Our Ref: 59916092 Var28: BCP/bcp  
Contact: Dr Brett C. Phillips

13<sup>th</sup> February 2023

## **PEER REVIEW OF A PLANNING PROPOSAL FOR 531 COBBITTY ROAD, COBBITTY**

Camden Council has commissioned a peer review of flood modelling undertaken as part of a Water Cycle Master Plan for 531 Cobbitty Road, Cobbitty. The primary aim of the peer review was to review the flood model prepared by Orion Consulting in comparison to flood modelling adopted by Council as part of the Nepean River FRMSP.

**Figure 7 Ground Level Differences (2022 Model – 2019 Model)**

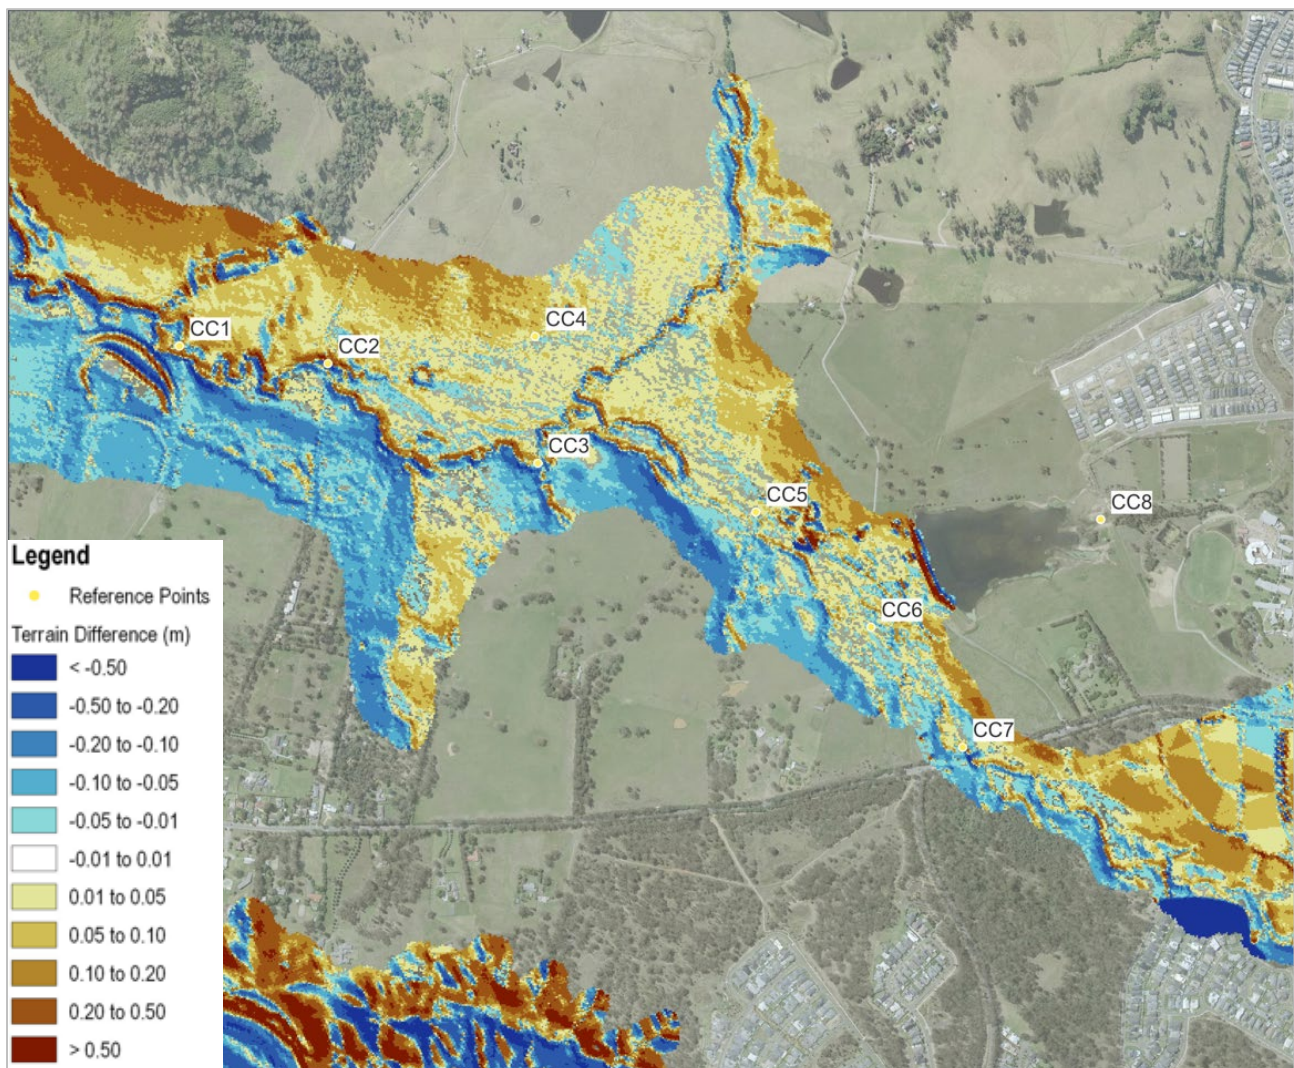
Notwithstanding the 2022 ground levels are in MGA2020 and the 2019 ground levels are in GDA94 a ground level difference plot is mapped in **Figure 7**.

- The creek lines are shadowed by ground level reductions and increases – this suggest that there is a slight difference between MGA2020 and GDA94 that has slightly displaced the creek lines in the two DEMs;

- There are generally reductions in ground levels south of Cobbitty Creek and generally increases north of Cobbitty Creek – it is unclear if this is due to differences in vegetation at the times the LiDAR was collected; and
- At the western end of the comparison new urban development appears to have occurred during the period between 2011 and 2019.

**Figure 11 Locations of PO Lines**

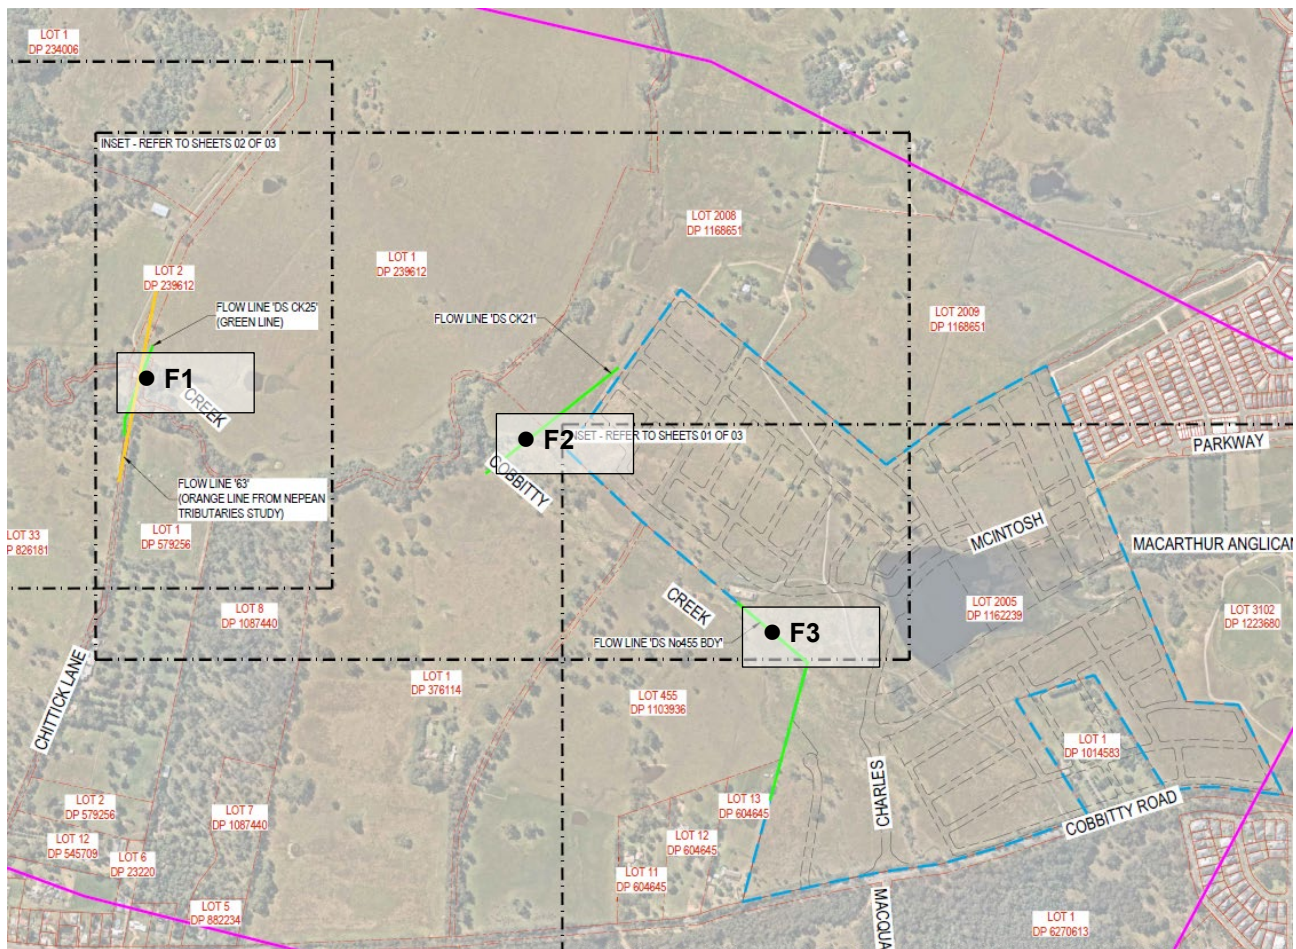
Table 5 compares the peak discharges and flood levels at Location F1 (see Figure 11).

- Location F3 - At the common boundary of No 455 Cobbitty Road (see Figure 11);
- Location F2 - Adjacent to the north-western site boundary within No. 415 Cobbitty Road (Downstream of CK21) (see Figure 11); and
- Location F1 – At the downstream end of sub catchment CK25 (see Figure 11).

**Figure 12 Comparison of 2022 and 2019 1% AEP Flood Extent**

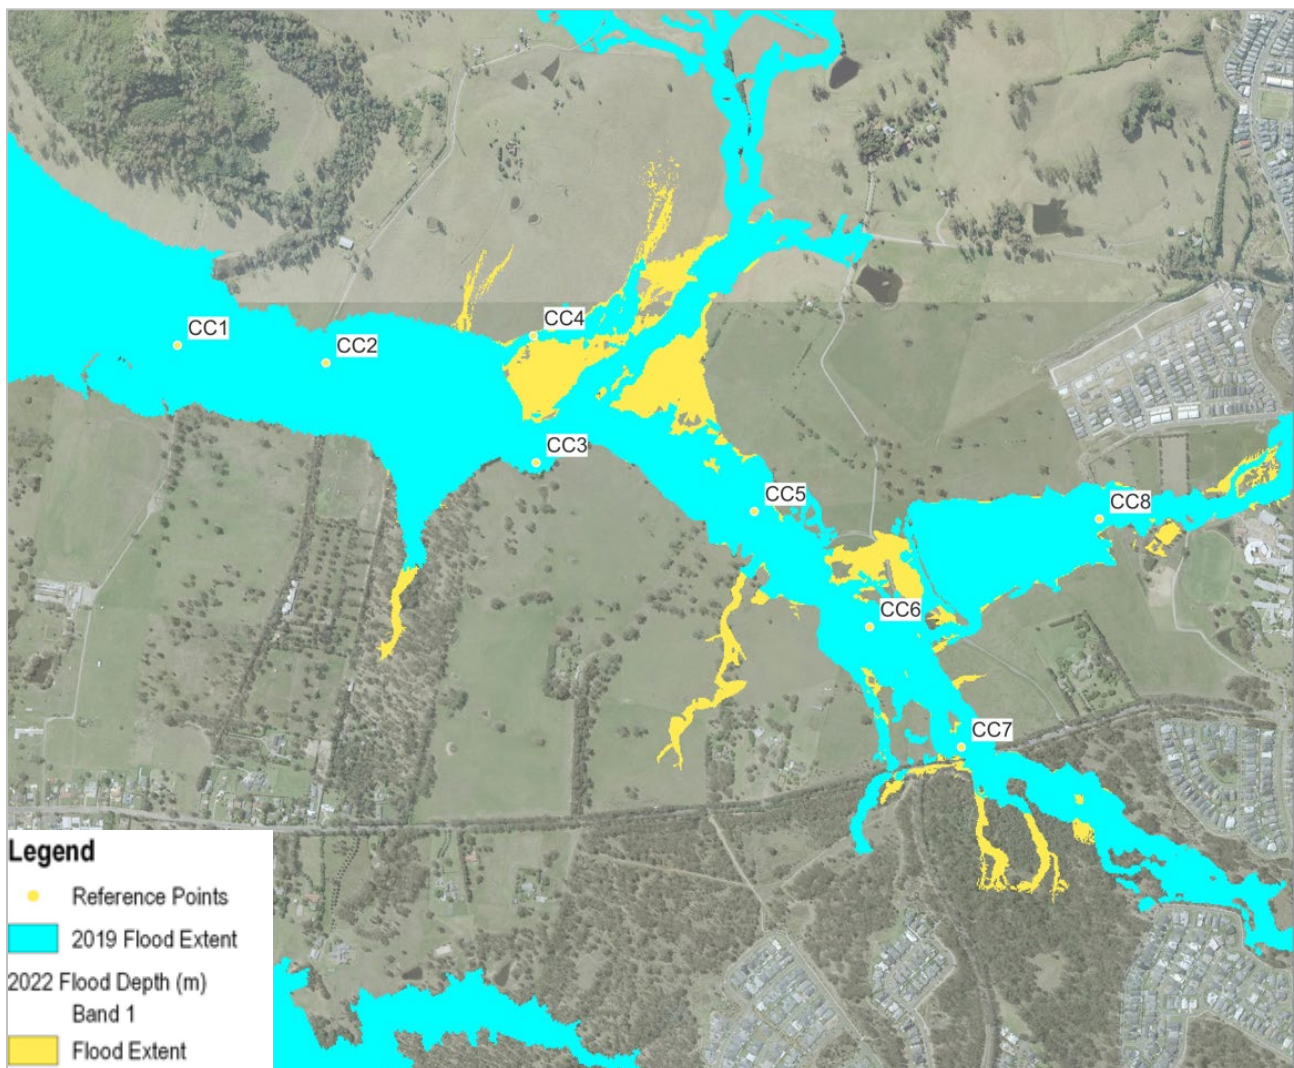
A comparison of the 1% AEP flood extents between the 2022 study and the 2019 study is given in **Figure 12**. It is noted from **Figure 12** that:

- The 2022 flood mapping identifies additional areas subject to 1% AEP inundation – this is attributed primarily to the difference in the adopted depth filters. The 2022 IWCM adopts a depth filter of 0.05 m while the 2019 study adopts a depth filter of 0.15 m; and
- A number of the small lateral drainage lines mapped in the 2022 IWCM have been mapped in the 2019 study as overland flow.

A comparison of the 1% AEP flood extents between the 2022 study and the 2019 study is given in **Figure 12**.

It is noted from **Figure 12** that:

**Figure 13 1% AEP Flood Level Differences** (after Orion Consulting, 2022)

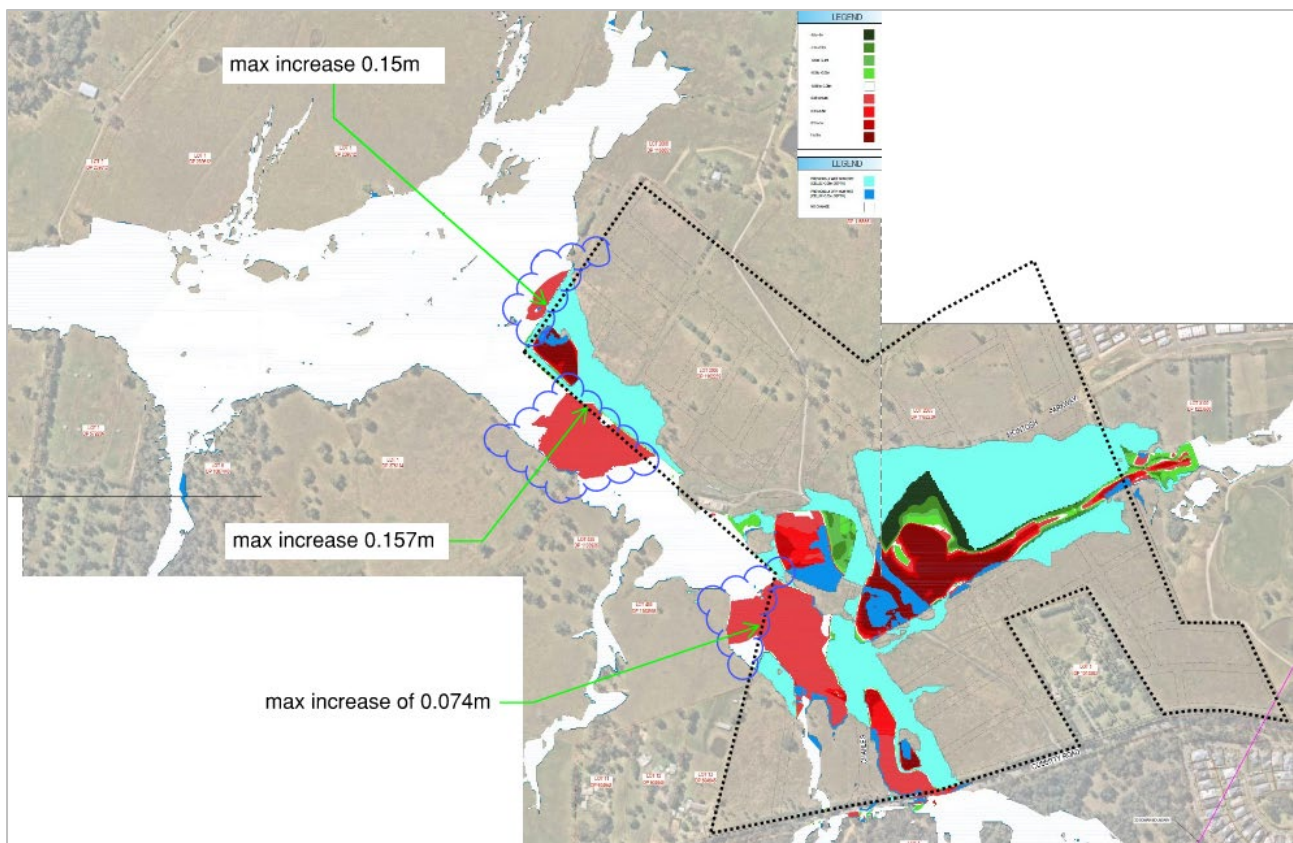
**Figure 13** is a composite plot of the 1% AEP flood level differences between Pre-development and Post-development conditions. The maximum flood level differences at three locations are also marked in **Figure 13**.

- The maximum 1% AEP flood level difference on land adjacent to the Masterplan area is less than the adopted criterion, namely, a maximum allowable increase in flood level of 0.2 m;
- The compliance with the flood velocity impact criterion could not be assessed because velocity difference plots were not included in the 2022 IWCM,
- Similarly the flow duration criterion was also not assessed.
